Phantom Landfill/PH3

Solid Waste - Correspondence - Enforcement - Response to Letter,
Request Status Update for Compliance Order on Consent #08-08-15-01,
September 17, 2010

KRW CONSULTING, INC.

Subject: Response to letter "Request Status Update for Compliance Order on Consent #08-08-15-01", September 17, 2010
KRW Project No.: 9110-03

Boring No.: TH-20
Logged By: B. Tilton
Sheet: 5 of 5

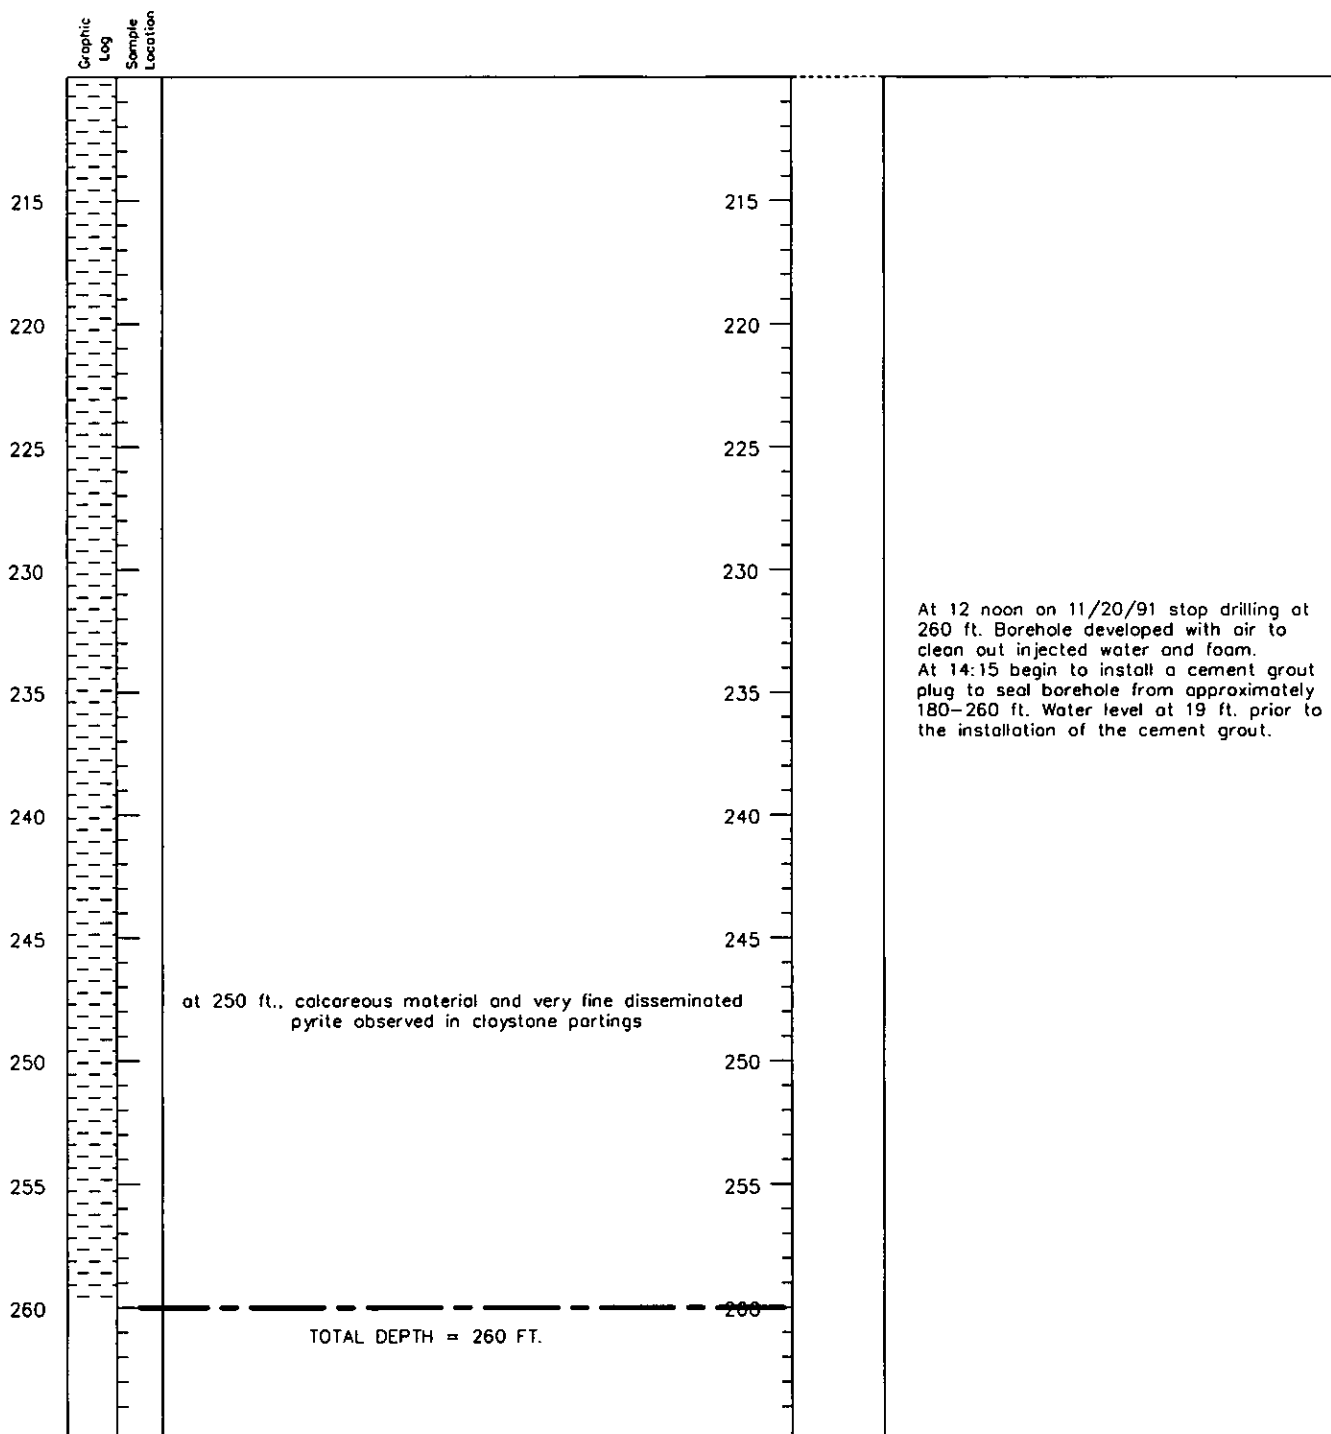
1. **Submittal of proposed assessment plan for the detailed hydrogeologic investigation necessary to modify the groundwater monitoring plan, with location and design of additional groundwater monitoring wells appropriate to the solidification basin, subject to Division review and approval (paragraph 32 of the Order).**

TWIN has performed a detailed analysis of the hydrogeologic conditions in the vicinity of the solidification basin and will implement changes in the Groundwater monitoring plan as appropriate. The hydrologic conditions beneath the solidification basin, as indicated by the nearest boreholes at the site, TH-9 and TH-20, indicate that there is no unconfined groundwater beneath the basin. The first aquifer to be encountered beneath the facility is the Greenhorn Limestone. Water was encountered in well TH-9 at a depth of approximately 91 feet and effectively screened in the uppermost water bearing zone between 90 and 105 feet below ground surface (BGS). Subsequent water level measurements in this well indicate a water level of less than 65 feet BGS. Water was encountered in well TH-20 at a depth of approximately 100 feet and effectively screened in the uppermost water bearing zone between 101 and 137 feet BGS. Subsequent water level measurements in this well indicate a water level of less than 50 feet BGS. Since this is clearly a confined aquifer, the aquifer is not a potential target for contamination from the facility. The site plan/geologic map (Figure 1) and well logs for TH-9 and TH-20 are included as attachments to this letter.

LEAK DETECTION WELL DETAIL PHANTOM LANDFILL

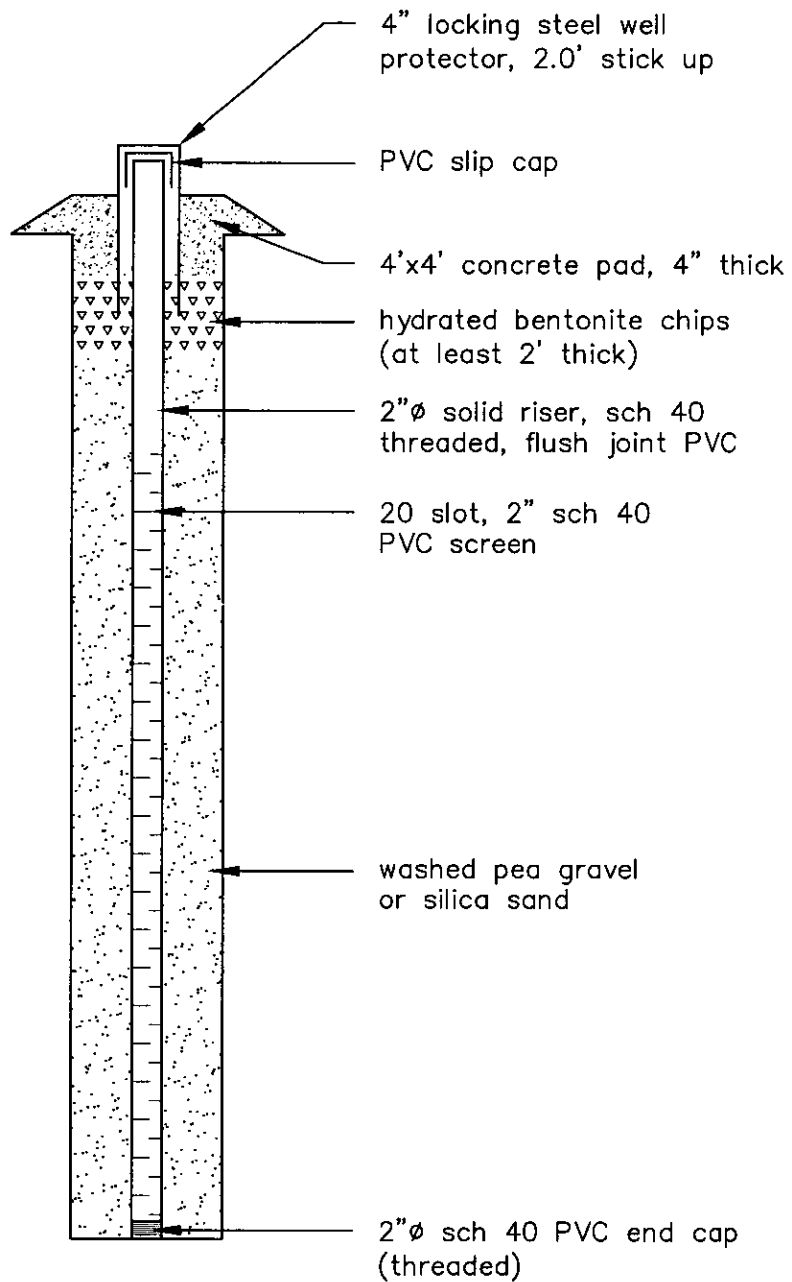
2. Installation of two new ground water monitoring wells, once approved (paragraph 33 of the Order).

Twin therefore proposes to install two additional monitor wells at the facility down-slope of the solidification basin, at locations as shown on the attached geologic map. It should be noted that one of these wells is located adjacent to the solidification basin sump. The wells, which will function as wet-dry wells, will be at least 2-inches in diameter to allow for sampling if water is encountered in the wells. The wells will be installed to depths below the base of the solidification basin sump and into un-weathered bedrock. The wells will be screened for nearly their entire length, from bottom to near surface, to intercept any fluid flow in weathered bedrock. A detail of the construction of the proposed wells is shown as attached Figure 2. Given the location and construction of these wells, they will serve as leak detection wells to detect any potential release from the solidification basin to allow for corrective action prior to any potential environmental impact. Please note that previous attempts were made to install

Both of the proposed wells will be checked for moisture on a weekly basis. The monitoring of these wells on a weekly schedule, as well as sampling for Appendix 1A and 1B parameters if water is encountered, will be included as a revision to the existing groundwater monitoring plan (Section 5.5 of the facility Design and Operations Plan). Twin will commence installation of these wells within 30 days of receiving approval from CDPHE.

TWIN agrees to install the wells as described in Item #1 above and reiterates the inappropriateness of completing another monitoring well in the confined aquifer beneath the solidification basin.
